800 East Denny Way

Project #3032084 Design Recommendation

X November 2019 | East Design Review Board

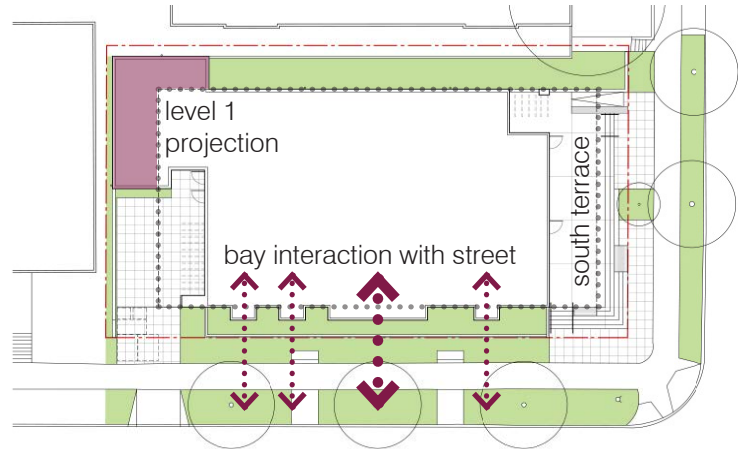
d. The Board agreed that the modulation of the rear (north) façade at the circulation core was not supported by the overall design concept of a simple massing form.
(DC2-B Architectural and Façade Composition)

North façade modulation at the central circulation has been eliminated in favor of a simple massing form and regular window openings at each congregate sleeping room programmed along the north edge.

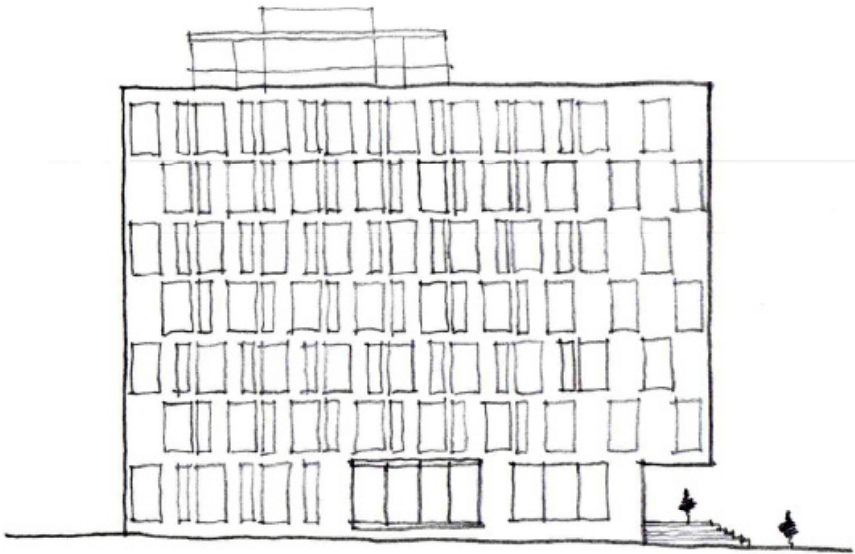
c. The Board provided guidance to plan ahead for venting and ensure that the venting design is highly integrated into the façade composition.
(DC2-B Architectural and Façade Composition)

The venting design is integrated into the façade system using dark bronze pre-formed metal vent panels that align and group with the window openings. The panels are perforated to allow for venting air circulation and will match the window frame color and other metals in the project.

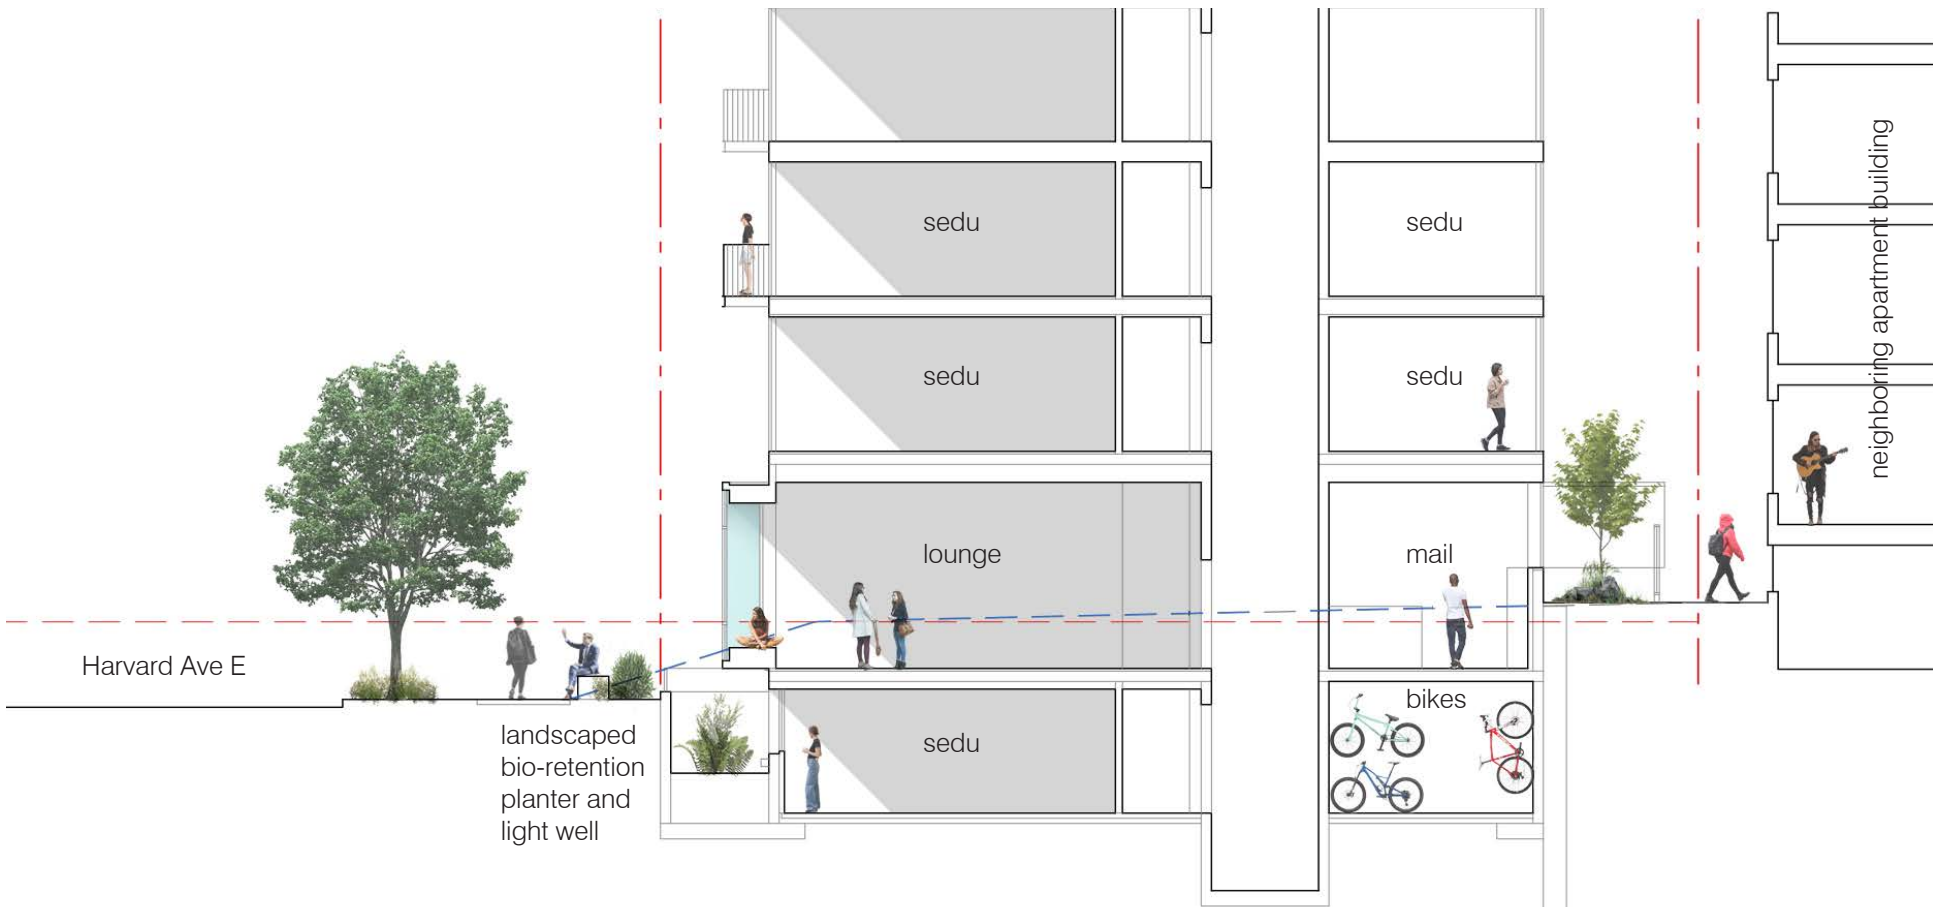
c. The Board was concerned with the proposed location of bike storage in the basement and provided guidance to incorporate bike storage at grade for easier access. The Board is open to bike storage on multiple levels and encouraged a variety of storage options to meet the differing needs of residents. (PL4-A Entry Locations and Relationships, PL4-B Planning Ahead for Bicyclists)

Six short term bike stalls are now provided under cover in the southeast corner next to the residential entry. At the north side twenty-four bikes can be stored under cover using a double stacking rack system accessed from the walking aisle next to the load/unload area. This has convenient access into the building at the north side. All outdoor and covered storage locations will be well lit with soffit integrated down-lighting. Additional long term bike storage is maintained in the basement.

commercial space in southwest corner

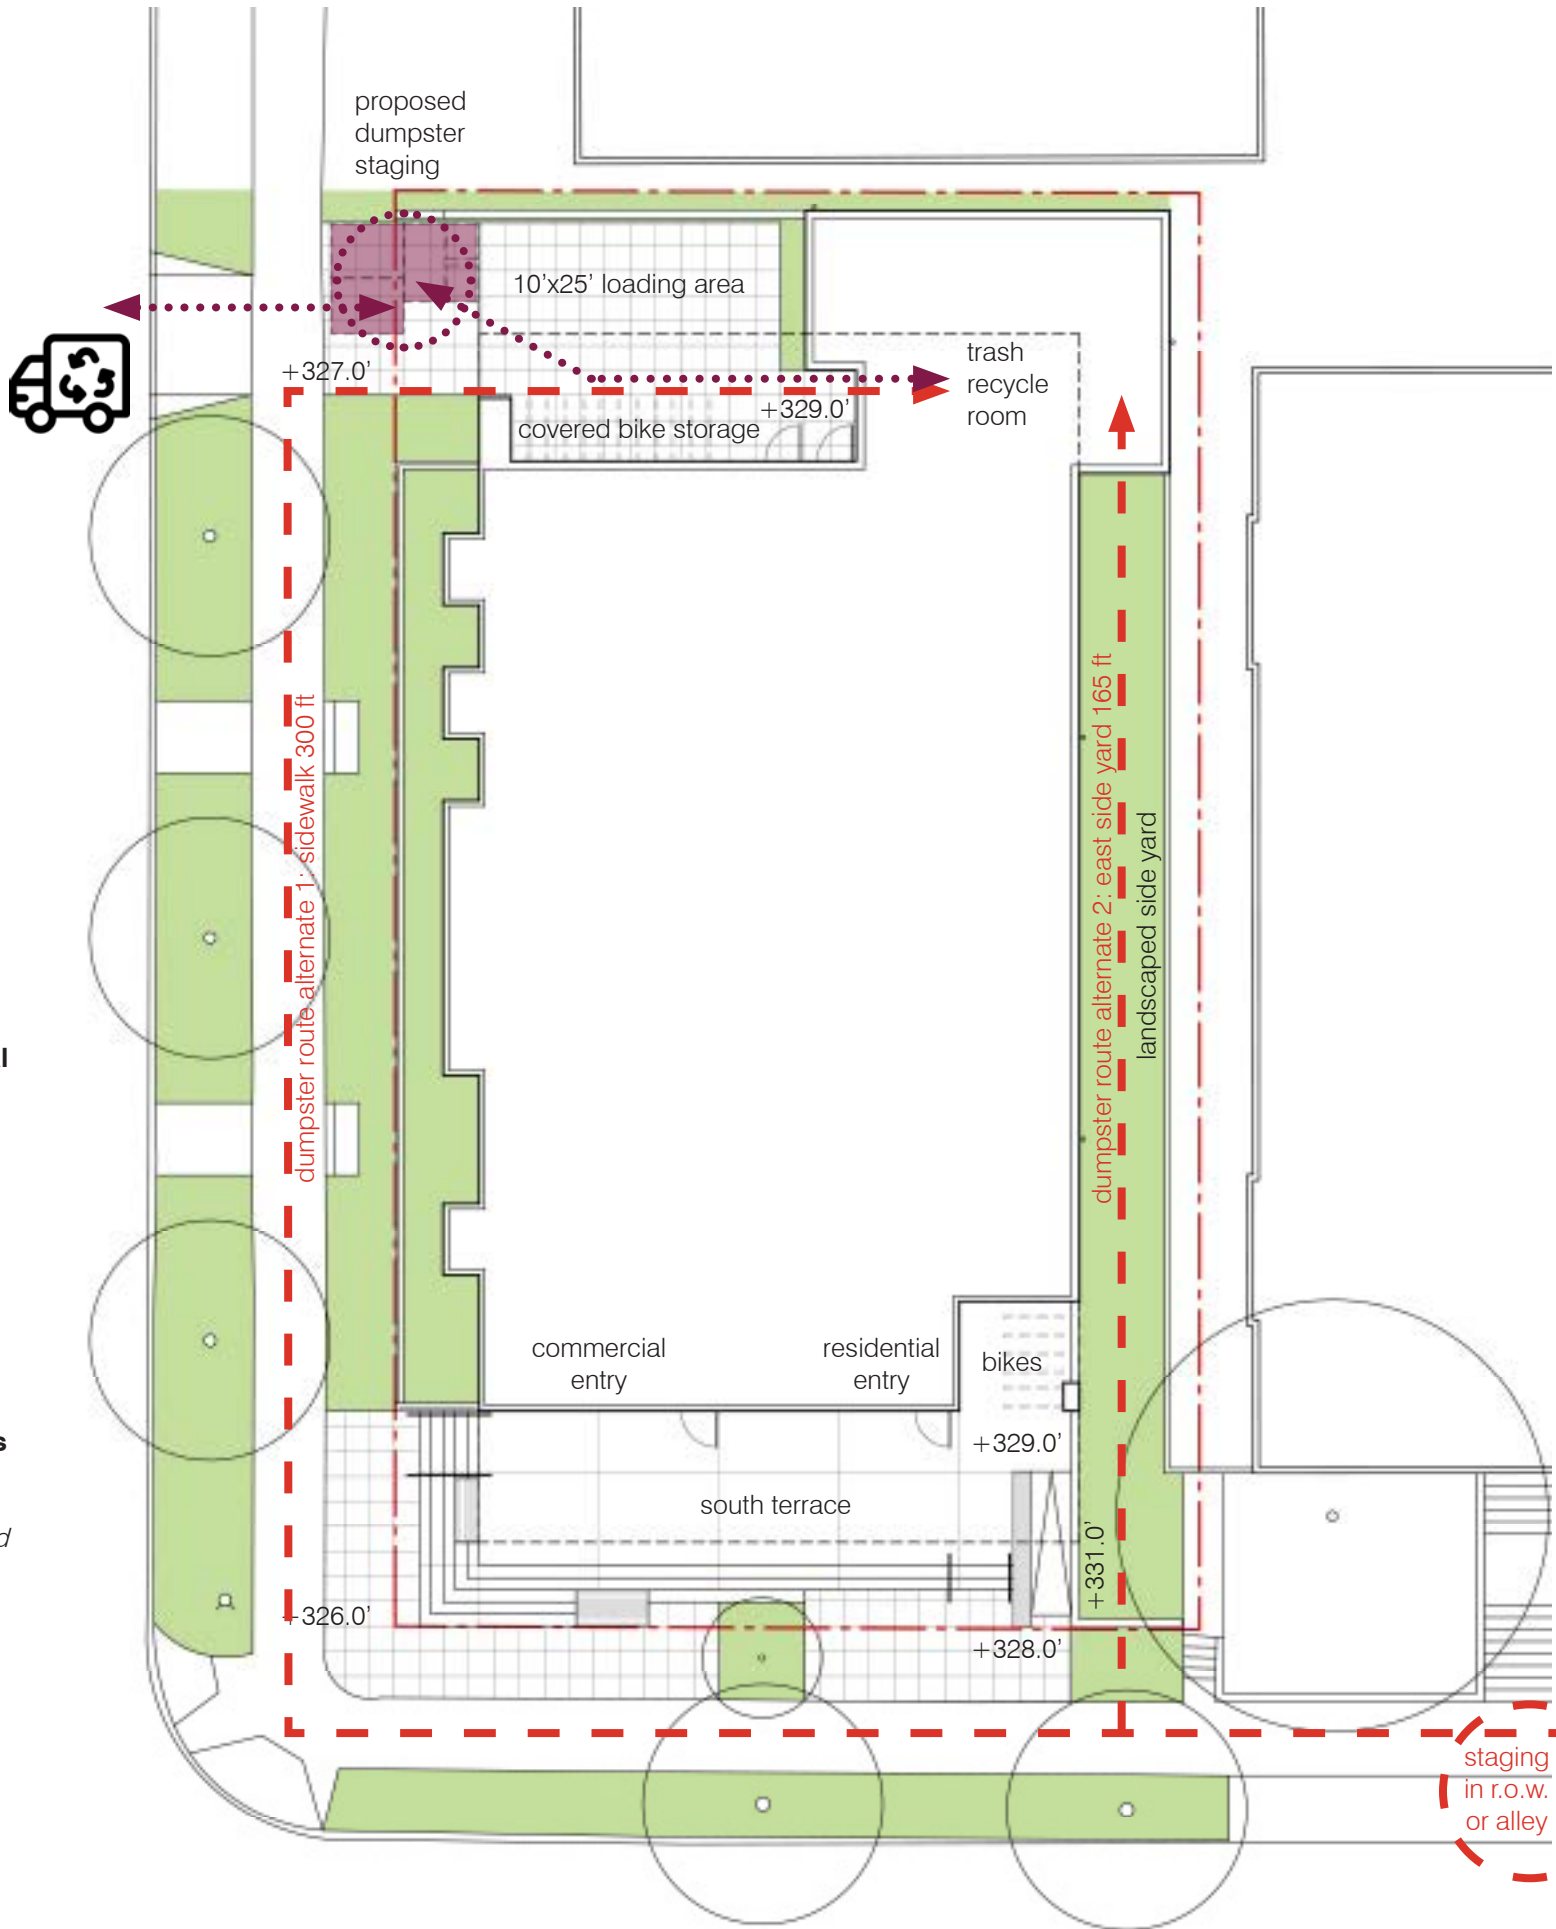
d. The Board expressed some concern with the viability of the commercial unit due to the location above grade and the small size of the space. However, the Board agreed that the location adjacent to the terrace could support a successful space and stated the importance of porosity between the commercial space and the terrace. The precedent image on pg. 37 of the EDG packet illustrating operable windows and outdoor seating was supported. (PL3-C-1 Porous Edge, PL3-I Human Activity, DC1-A-1 Arrangement of Interior Uses)

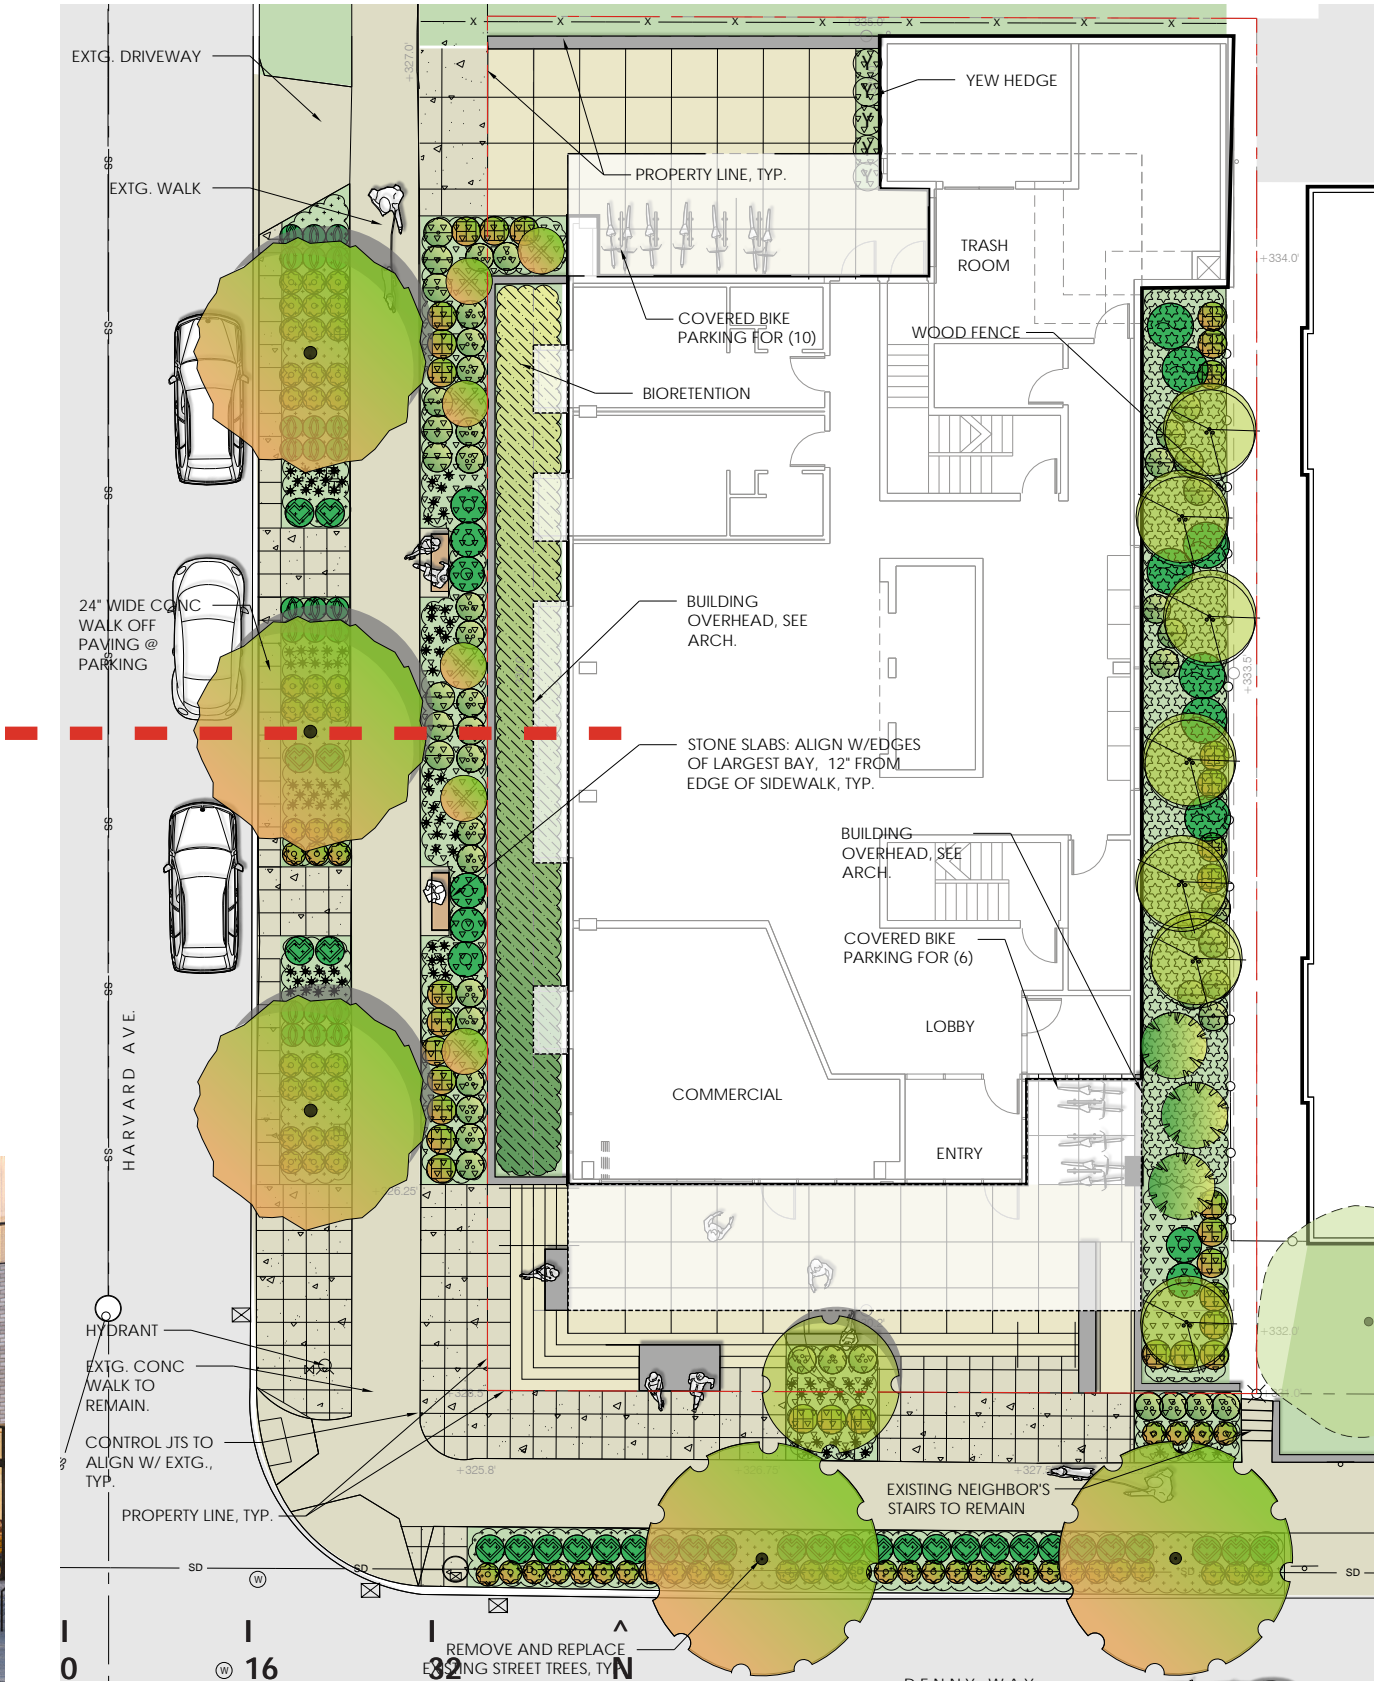
a. The Board generally supported the indicated direction of the landscape concept and observed that the landscaping and hardscaping could be more playful in contrast with the sobriety of the building.
(DC4-D Trees, Landscape and Hardscape Materials, CS1-D Plants and Habitat)

The landscape concept has been further developed with Urban Forestry approved street trees, right-of-way plantings, and on site landscaped edges that integrate with the project architecture.
